## Trailer Air Suspension and Mechanical Suspension Air Disc Brake Product Line Update

### Product Change Notice for P89 Series Air Disc Brakes

Effective July 2016

Figure 1

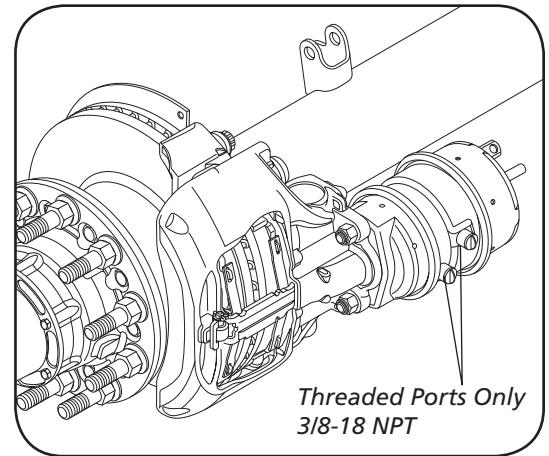
For standard applications, both the **NEW P89** and **P89 PLUS** will use brake chambers with 3/8-18 NPT threaded ports facing away from the axle (**Figure 1**). Refer to XL-SA20022WI Rev C available on the SAF-HOLLAND website, [www.safholland.us](http://www.safholland.us), for complete details, including special configurations for yoke mount and underslung suspensions.
